## INTERIM CONSTRUCTION DEFICIENCY REPORT

SHALLOW STOP END BELLS USED WITH SCHEDULE 40 PVC CONDUIT

Name of Station:	St. Lucie Plant - Unit #2
Owner:	Florida Power & Light Co.
Architect/Engineer:	Ebasco Services, Incorporated
Date of Deficiency:	November 7, 1979
Interim Report Filed:	December 7, 1979
Supplier of Deficient Component:	Carlson Products
Final Report Filed:	April 11, 1980

FIGURE 1

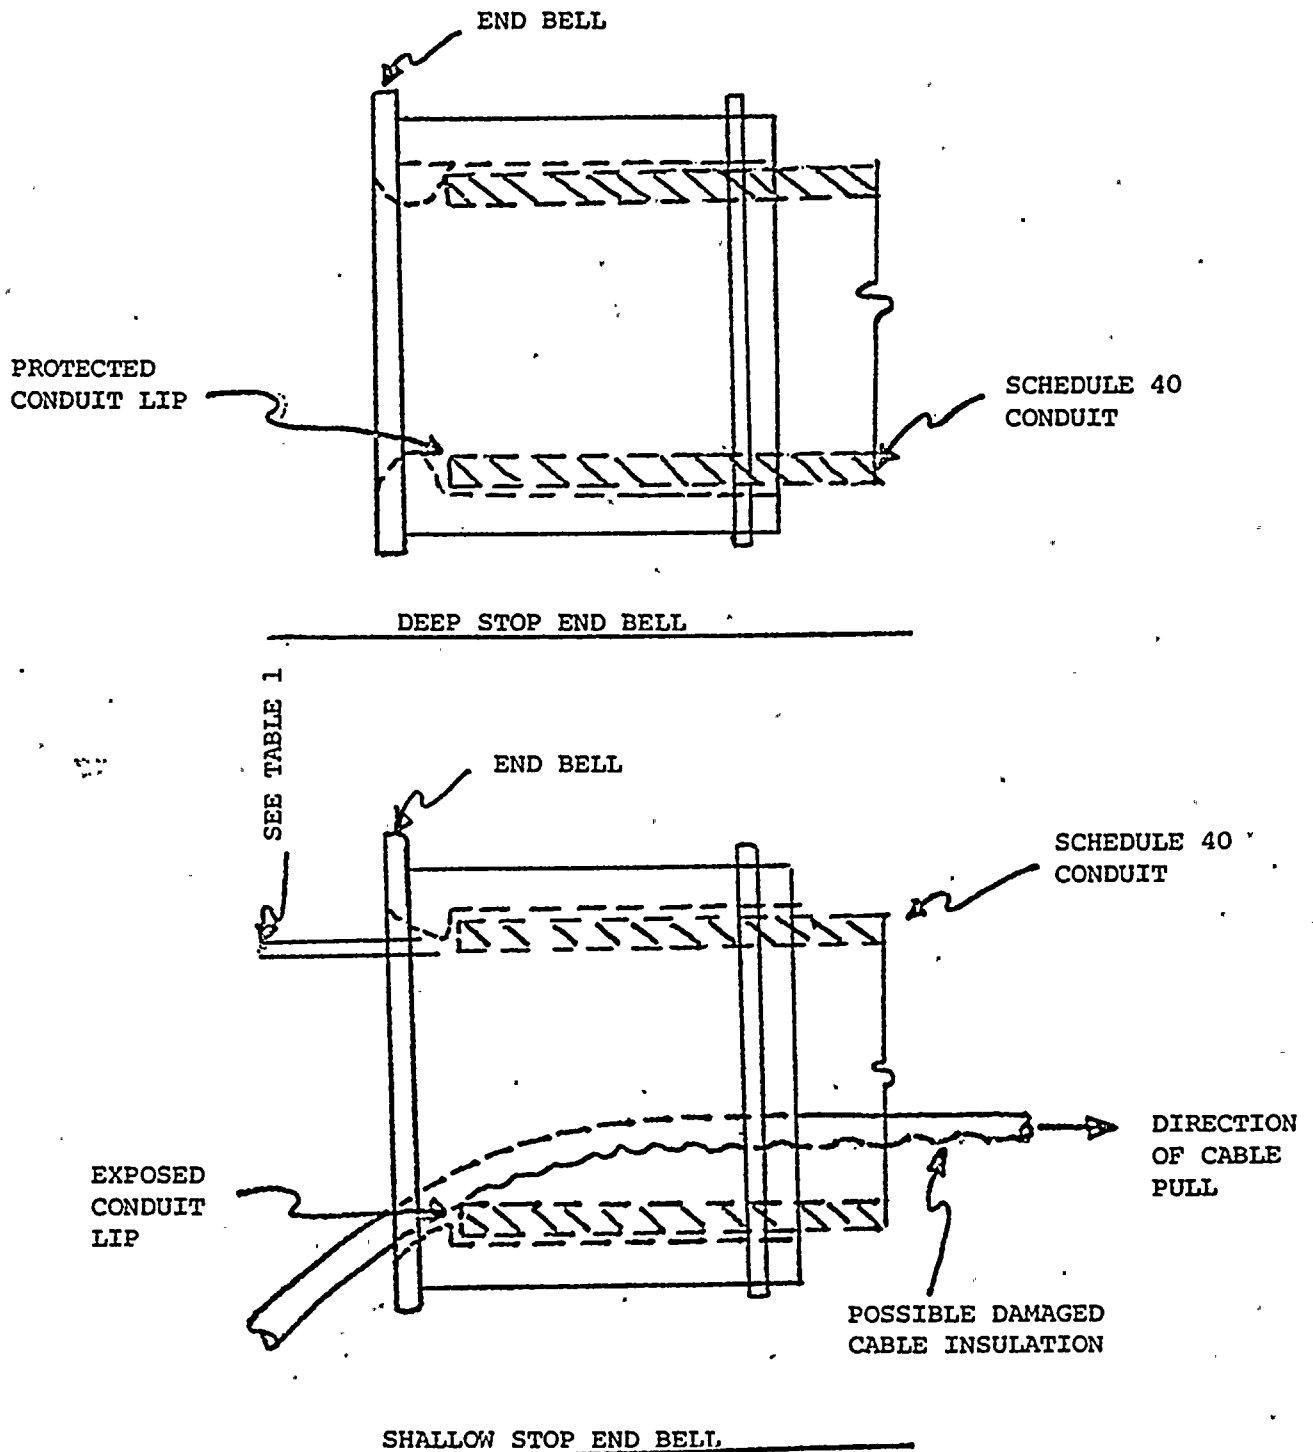
In January 1978 when purchase order 49210-27358S SL-12008 for PVC Conduit was originally prepared, only the catalog number, E997, was used to identify the required end bells because Ebasco Services had been previously advised by Carlon that only one type of end bell was manufactured for schedule 40 PVC Conduit. This condition also existed for purchase order 55000-26948S SL-14939 issued in June of 1979. Subsequent investigation showed that Carlon makes both deep stop and shallow stop end bells with the same E997 series catalog number. Both types are made from the same PVC compound of identical chemical composition. The difference between parts is only in stop height dimension. These differences are illustrated in figure 1.

The shallow stop end bell will result in an exposed conduit edge ranging from approximately 0.077 to 0.1315 inches when used with schedule 40 PVC Conduit. This edge could shave the cable jacket during cable pulling operations as illustrated in Figure 1. A summary of exposed conduit lip calculations is provided in Table 1 for end bells of various diameters.

or beveled to provide a smooth transition between the end bell and conduit where shallow stop end bells have been installed to eliminate any possibility of the edge scraping the cable insulation.

6. Quality Control will 100% inspect all future shipments of end bells for proper stop height dimensions.
7. The exposed conduit lip will be reamed prior to cable installation on all locations where shallow stop end bells have been used.
8. Quality Control will inspect 100% all locations prior to pulling class IE cables and will perform surveillance of balance of plant cable pulling to assure that all conduit lips have been reamed.
